REMARKS

Appl'n No.: 10/698,969
Title: Method and Apparatus for Remote...
Inventors: Dimiter S. Zagoroff
Annotated Marked-Up Drawings

Fig. 3

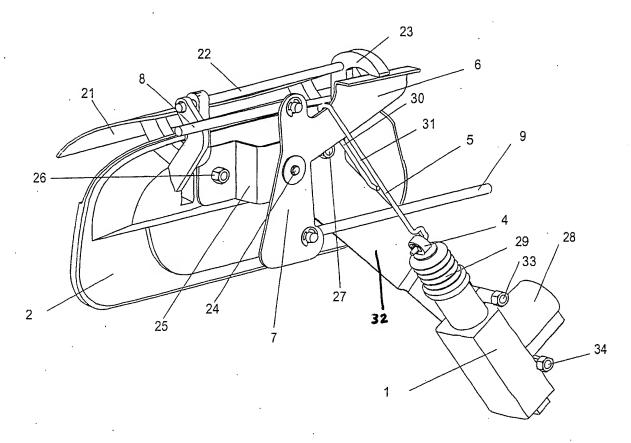
Fig. 3 has been amended to include reference numeral 32.
